UNITED STATES PATENT AND TRADEMARK OFFICE

APPLICATION NO.	FILING DATE	FIRST NAMED INVENTOR	ATTORNEY DOCKET NO.	CONFIRMATION NO.
10/678,028	09/29/2003	Sameer P. Pendharker	TI-33654	9934
23494	7590	04/20/2006	EXAMINER	
TEXAS INSTRUMENTS INCORPORATED			DOAN, THERESA T	
P O BOX 655474, M/S 3999			ART UNIT	
DALLAS, TX 75265			PAPER NUMBER	
			2814

Office Action Summary	Application No. 10/678,028	Applicant(s) PENDHARKER ET AL.	
	Examiner Theresa T. Doan	Art Unit 2814

DETAILED ACTION

FIG. 1

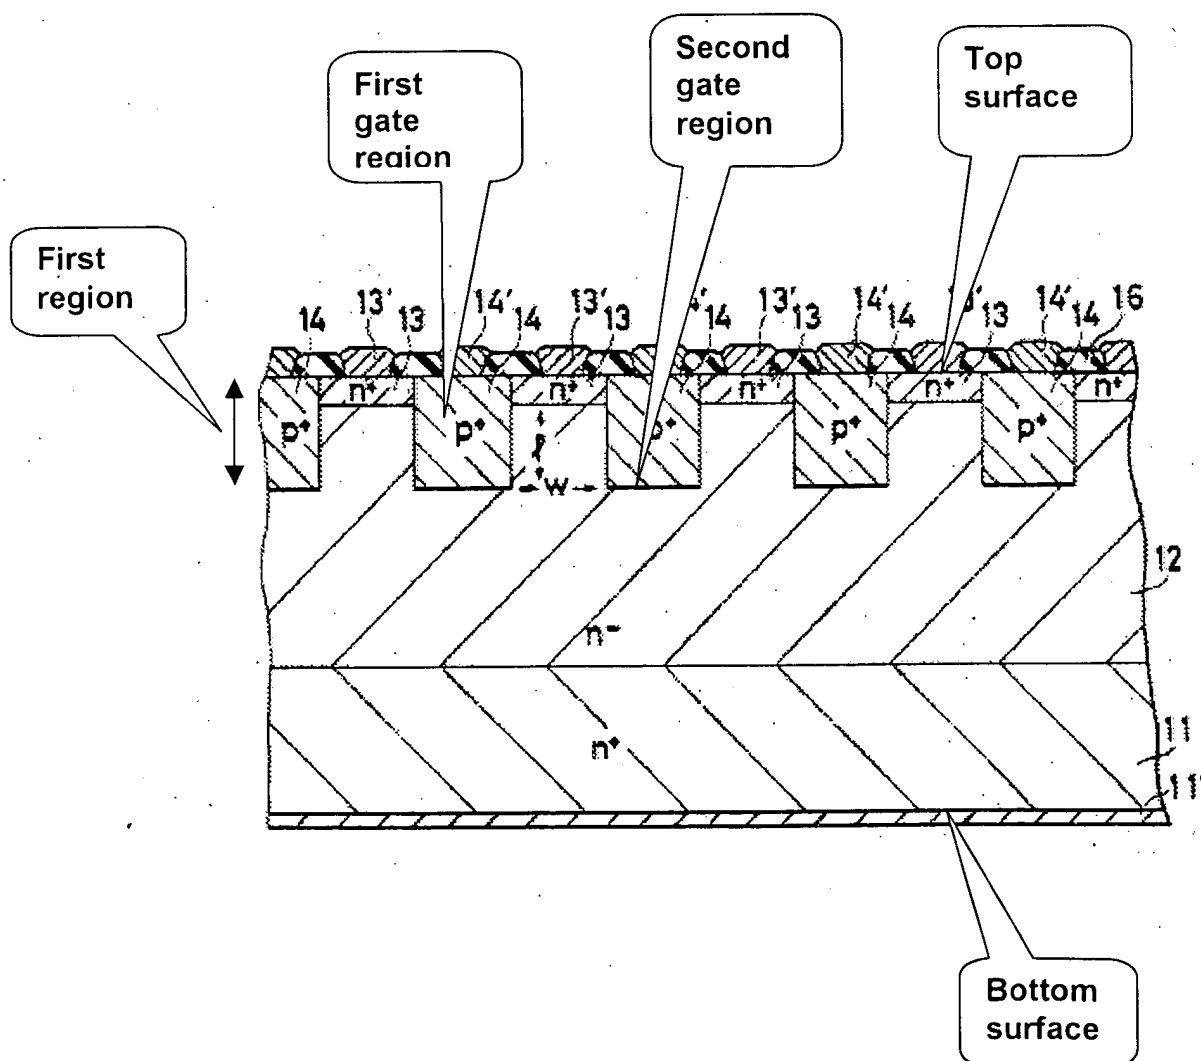
Regarding claim 2, Nishizawa (Fig. 1) discloses an integrated-circuit device, comprising: a substrate 11 (column 2, line 66), having a top surface and a bottom surface; and a vertical JFET (column 3, lines 25-29), including: a first region near the top surface (corresponding to the top portion of layer 12, see Fig. 1 labeled by the examiner below); a first and second gate regions 14 in a first region near the top surface of the substrate (corresponding to the top portion of layer 12, see Fig. 1 labeled by the examiner below and column 3, line 2), each having a top surface, a bottom surface and a side surface; the side surfaces of the first and second gate regions 14 being

substantially parallel to each other and substantially perpendicular to the top surface of the substrate 11 (see Fig. 1 Labeled by the examiner below); the top surface of the first gate region 14 being electrically communicable to a gate terminal 14' (column 3, lines 2-5); a channel region (ℓ) in the first region, between the first and the second gate regions 14 (column 3, lines 10-15) having side surfaces adjacent to the side surfaces of the gate regions 14, a top surface, and a bottom surface; the top surface of the channel region (ℓ) electrically communicable to a source terminal 13', the bottom surface of the channel region (ℓ) electrically communicable to a drain terminal 11'; and the JFET operable to pass an electric current between the source terminal 13' and the drain terminal 11', the electric current flowing in the channel region (ℓ) in a direction vertical to the top and bottom surfaces of the channel region.

Regarding claim 3, Nishizawa (Fig. 1) discloses that the electric current passes the channel region (1) upon a biasing voltage being applied between the source terminal 13' and the drain terminal 11' (column 5, lines 64-68 through column 6, lines 1-7), and the magnitude of the current in the channel region is controllable with a biasing voltage at the gate terminal 14' (column 3, lines 48-56).

Regarding claim 9, Nishizawa (Fig. 1) discloses that the substrate 11 is a bonded wafer having a bonded layer 12 formed thereon.

This argument is not persuasive because Figs. 24A-24C are not relied on for teaching JFETs as asserted by Applicant, but rather, Fig. 1 is relied on for teaching JFETs as claimed. Clearly, Fig. 1 of Nishizawa '575 discloses a JFET having "junction-gate" 14 (see abstract) in contact with source regions 13.

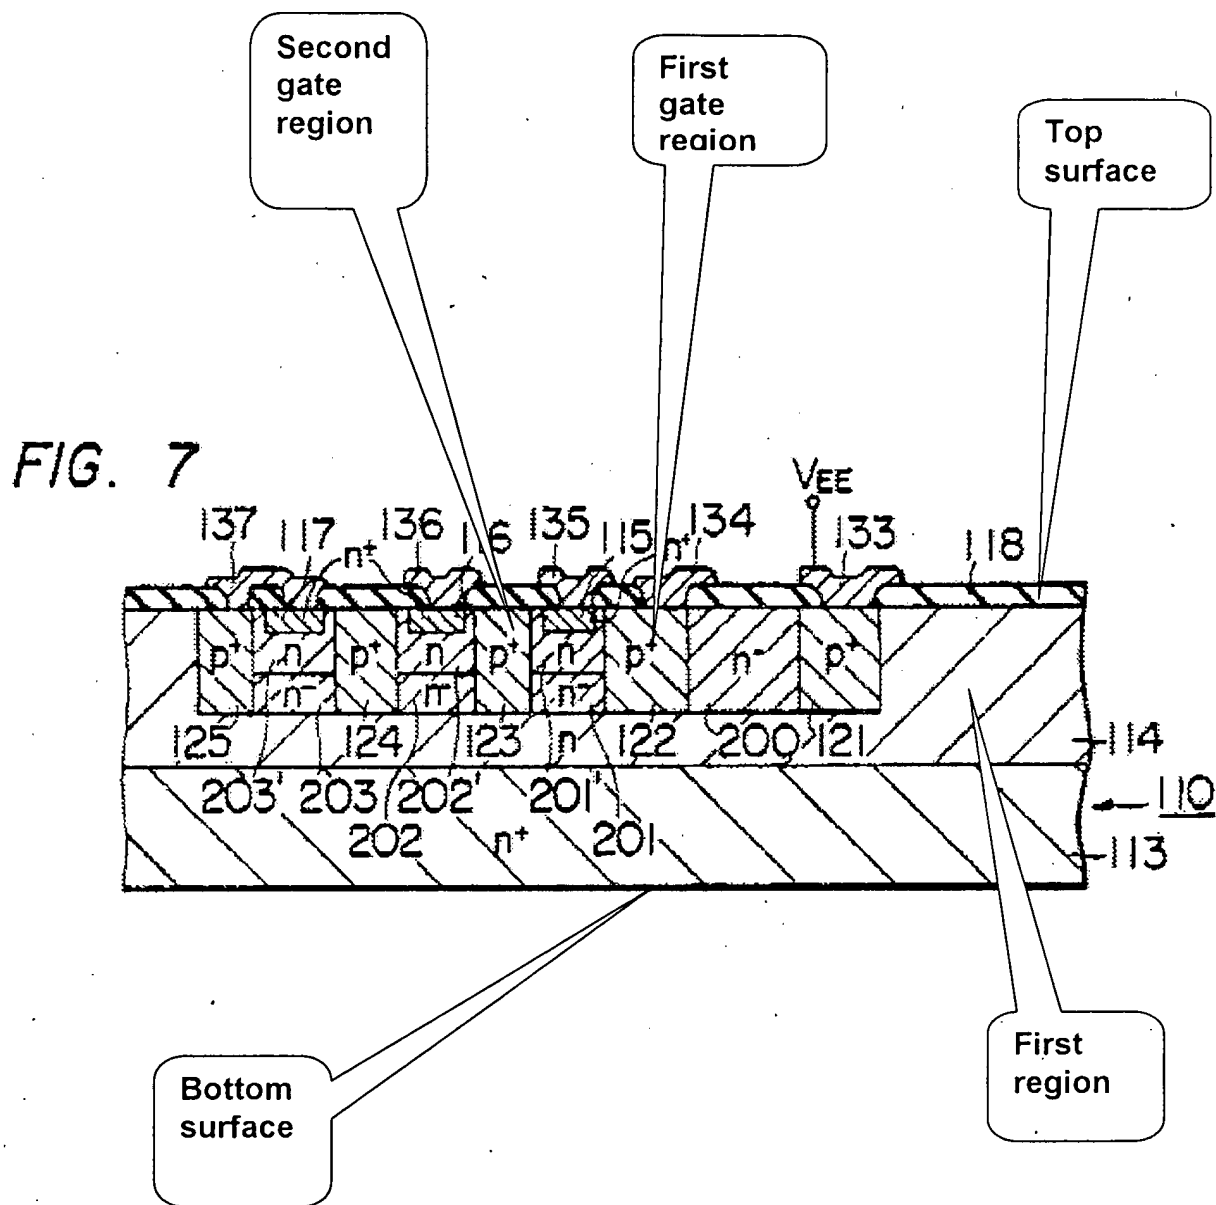
Regarding claim 2, Nishizawa '618 (Fig. 7) discloses an integrated-circuit device, comprising: a substrate 113 (column 6, lines 20-22), having a top surface and a bottom surface; and a vertical JFET (see abstract), including: a first and second gate regions (122,123) in a first region 114 near the top surface 113 (column 7, lines 9-10), each having a top surface, a bottom surface and a side surface; the side surfaces of the first and second gate regions (122,123) being substantially parallel to each other and substantially perpendicular to the top surface of the substrate 113 (see Fig. 7 Labeled by the examiner below); the top surface of the first gate region 122 being electrically communicable to a gate terminal 134; a channel region 201 in the first region 114 (column 9, lines 22-26), between the first and the second gate regions (122,123) having side surfaces adjacent to the side surfaces of the gate regions (122,123), a top surface, and a bottom surface (column 9, lines 32-34); the top surface of the channel region 201 electrically communicable to a drain terminal 135 of a drain region 115 (column 7, line 10), the bottom surface of the channel region 201 electrically communicable to a source

terminal 113 (column 7, lines 13-15); and the JFET operable to pass an electric current between the source/drain terminal 135 and the source/drain region 113, the electric current flowing in the channel region 114 in a direction vertical to the top and bottom surfaces of the channel region 114 (column 7, lines 8-13).

Regarding claim 3, Nishizawa '618 (Fig. 7) discloses that the electric current passes the channel region 201 upon a biasing voltage being applied between the source terminal 113 and the drain terminal 115 (column 11, lines 4-8), and the magnitude of the current in the channel region is controllable with a biasing voltage at the gate terminal 122 (column 7, lines 42-49).

Regarding claim 10, Nishizawa '618 discloses that the first gate region 122 has a pill-box shape with a substantially flat top surface and bottom surface and a side surface substantially perpendicular to the top and bottom surfaces (see Fig. 7 above).

Regarding claim 11, Nishizawa '618 discloses that the channel region 201/202 has a ring shape enclosing the first gate region 123, a bottom surface substantially coplanar to the bottom surface of the first gate region 123 and a top surface substantially coplanar to the top surface of the first gate region 123.

Regarding claim 12, Nishizawa '618 discloses that the second gate region 124/123 has a ring shape enclosing the channel region 202, a bottom surface substantially coplanar to the bottom surface of the first gate region 123 and a top surface substantially coplanar to the top surface of the first gate region 123.
